**SITE PLAN REVIEW SHEET
ENVIRONMENTAL VARIANCE REQUEST ONLY**

CASE: SP-2021-0446D

PROJECT NAME: 8020 Parmer SH 130 NW

DESCRIPTION OF VARIANCES:

Floodplain Modification

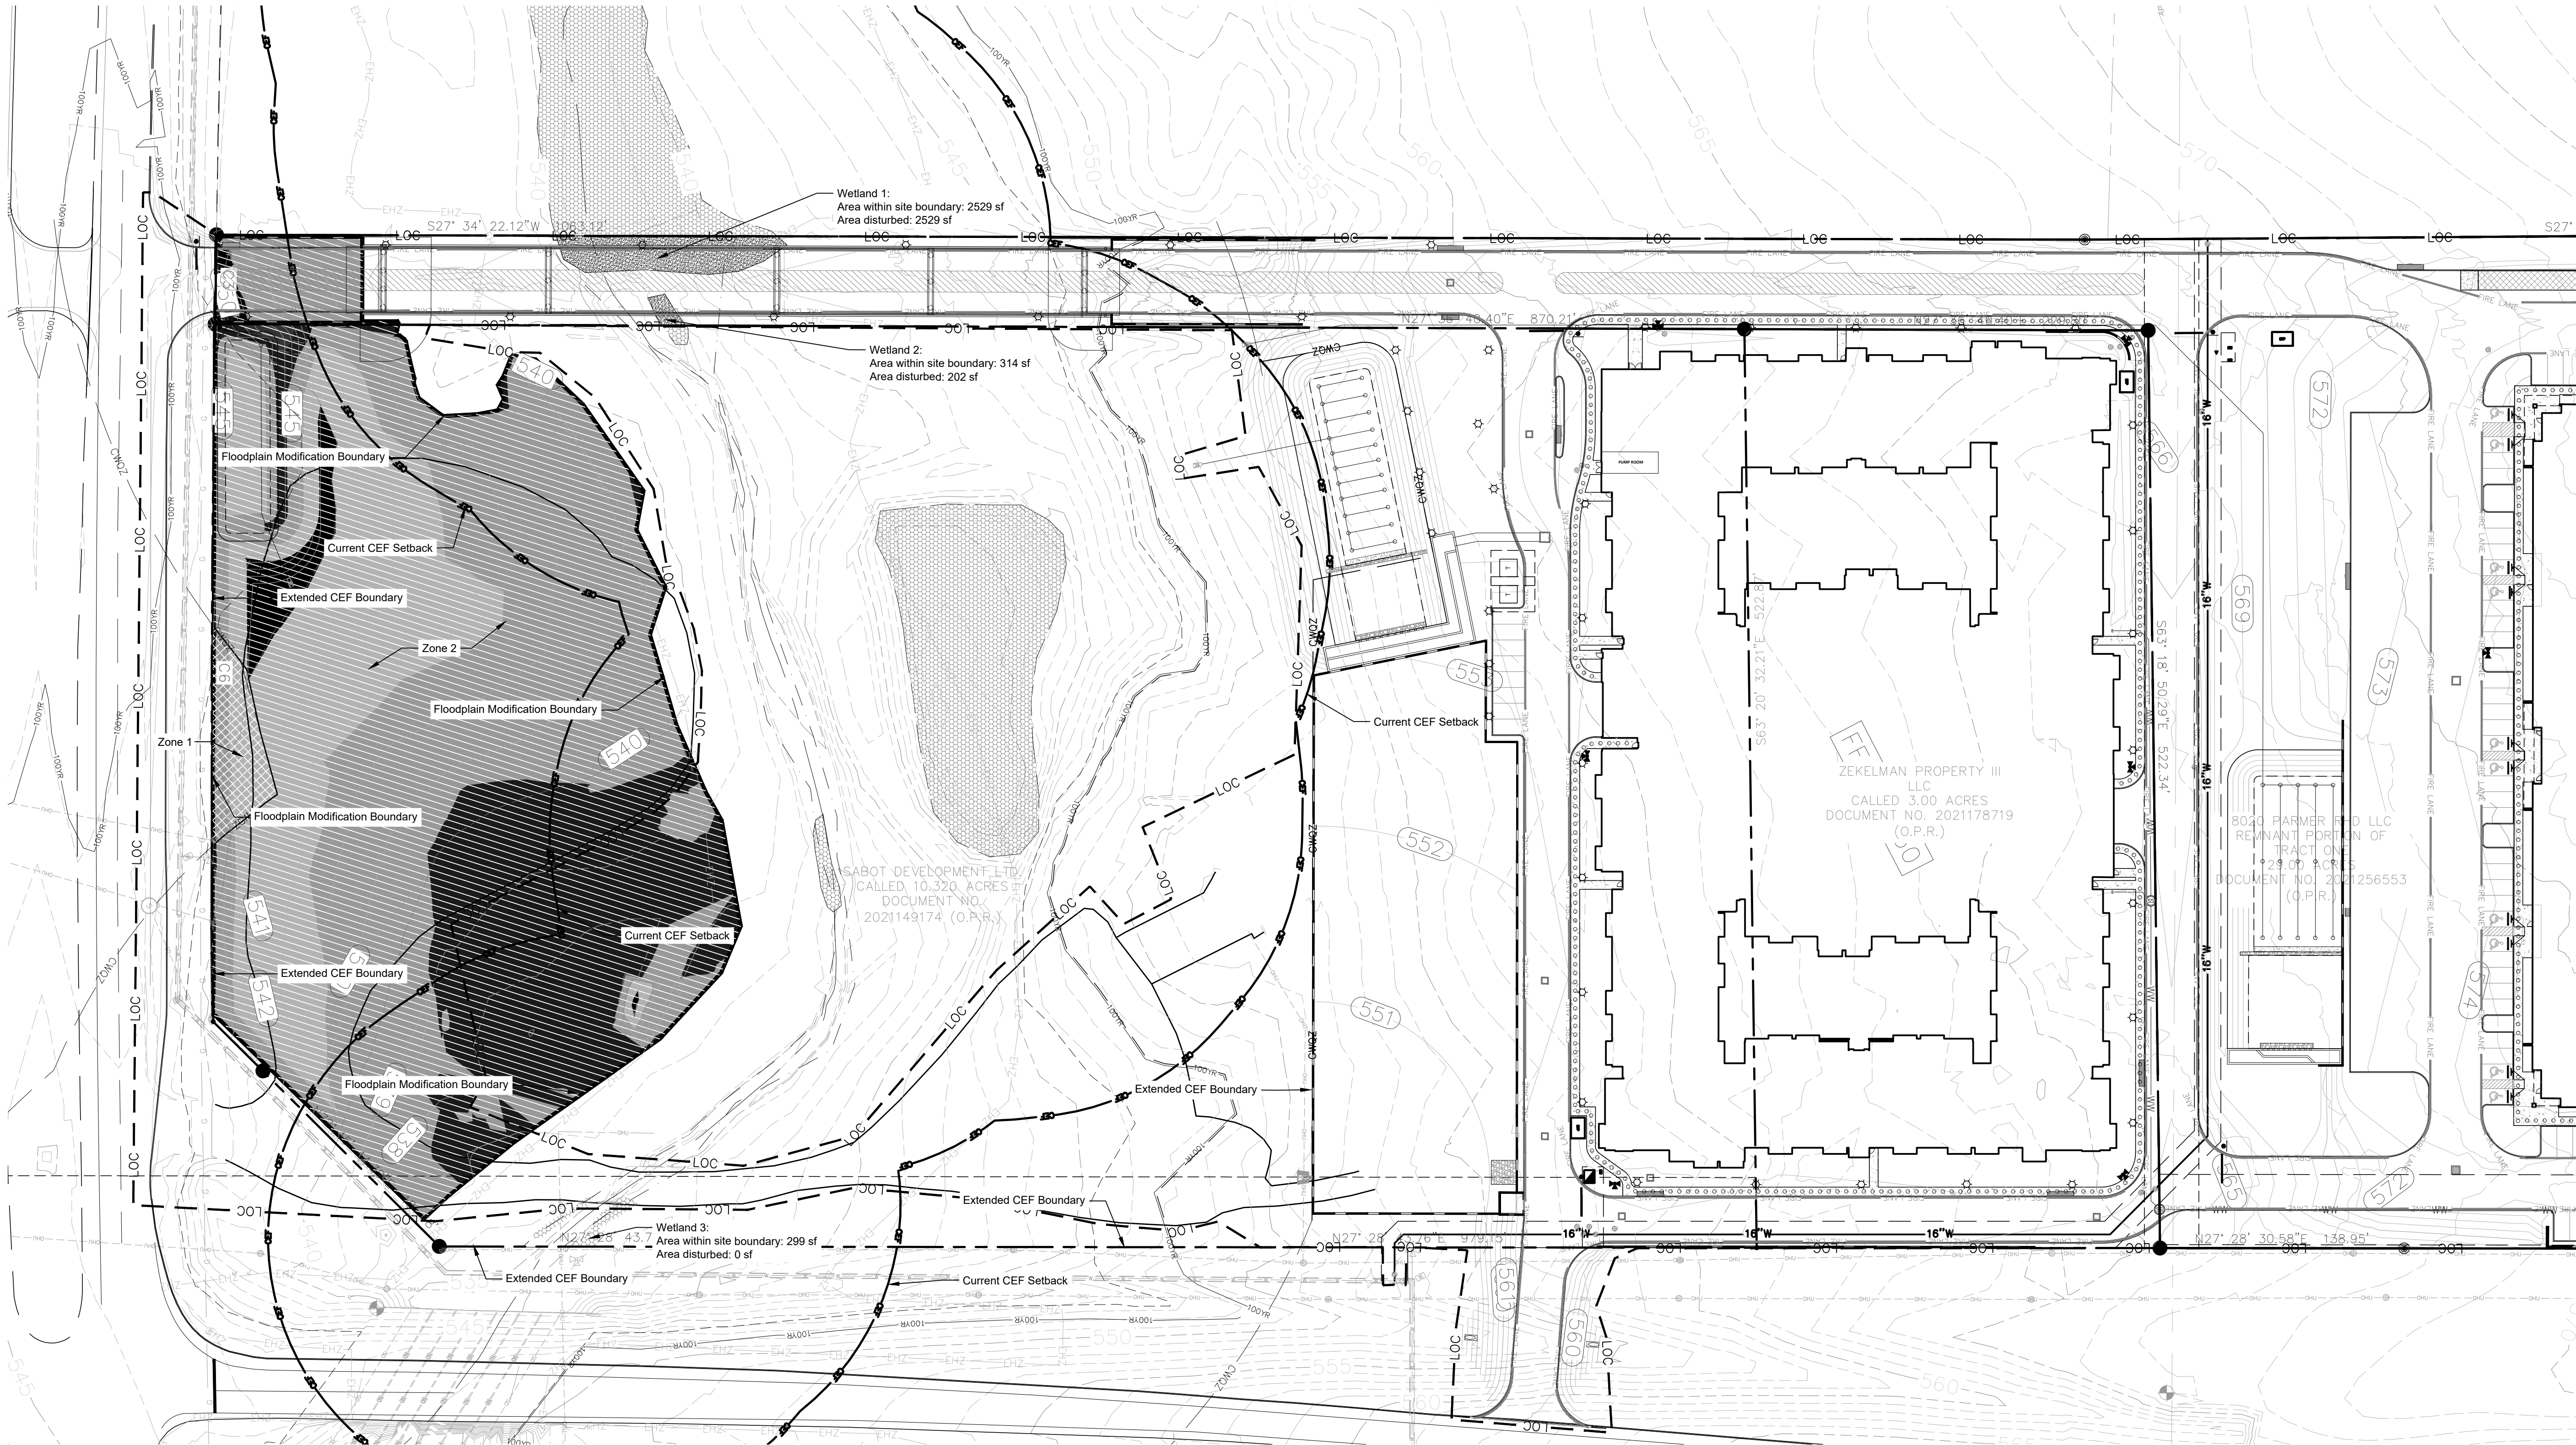
The Critical Water Quality Zone variance is required because floodplain modification is necessary to offset the floodplain volume displaced by the bridge. There are no adverse impacts proposed to the floodplain elevations on adjacent properties with the proposed improvements, per the requirements of the code.

Yes The proposed floodplain modification is the minimum necessary to build the bridge as required by code for safe access, with the low chord of the bridge two feet above the water surface elevation of the 100-year floodplain.

1. The applicant will pay into the Riparian Zone Mitigation Fund for both the area of Zone 1 (Floodplain outside of the CWQZ) and the area of Zone 2 (Floodplain within the CWQZ) using the appropriate ratios per ECM 1.7.6.
2. Development of the site will be carried out as described in Exhibits 1-6, attached in the staff variance packet.
